SHIRE OF BALLINA		
COMPTON DRIVE, LIGHTHOUSE PARADE CONCEPT COMPTON DRIVE REALIGNMENT OPTION 4		
Scale	AS SHOWN	Plan No. SR23.071/04
Sheet 1 Of 1 Sheets		A1

DRAFT CONSENT CONDITIONS

STAGE 1 & STAGE 2

- Perspectives of Clubhouse and Patrol Buildings, Sheets 1 to 8 inclusive, Dated 6 March 2009;
- The Compton Drive/Lighthouse Parade Re-Alignment Road Plan, No. SR23.071/04, Amendment No. 3 Dated May 2010.

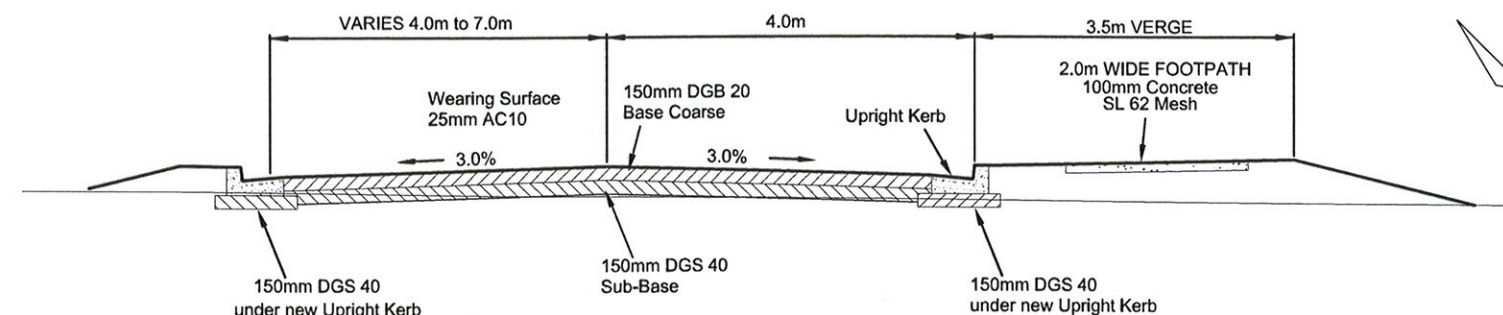
The width of pavement of the re-aligned section of Compton Drive, from the intersection with the re-aligned section of Lighthouse Parade west of the proposed Carpark, to where the new section of Compton Drive meets with that section of Lighthouse Parade that runs north/south along the beachfront, (as indicated on drawing SR23.071/04, shall be a minimum of 11 metres in width in accordance with Council's requirements, with the width of the pavement reduced to match the width of the existing pavement where the proposed roadwork's meet the existing pavement.

The kerbing/guttering to the northern side of the new carriageway from approximately chainage 180 eastward to the limit of works shall comprise barrier kerb. All other locations are to comprise a swale drain unless noted otherwise on the design plans.

The Engineering plans for Compton Drive be amended to provide linemarking in accordance with AS1742 and AS1744 in the region of the Bus zone to differentiate through traffic from other vehicles.

drawing title
**LANDSCAPE
MASTER PLAN**

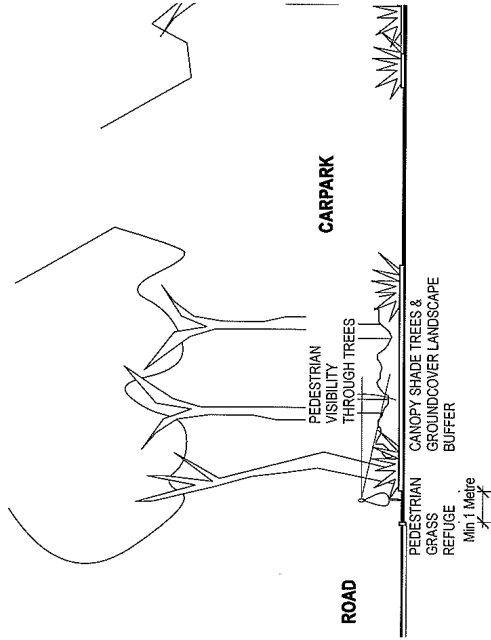
- 12.28. The applicant is to revise the submitted Landscape Plan to only include species which are endemic to the locality. All species listed under the Threatened Species Conservation Act (1995) are to be removed.
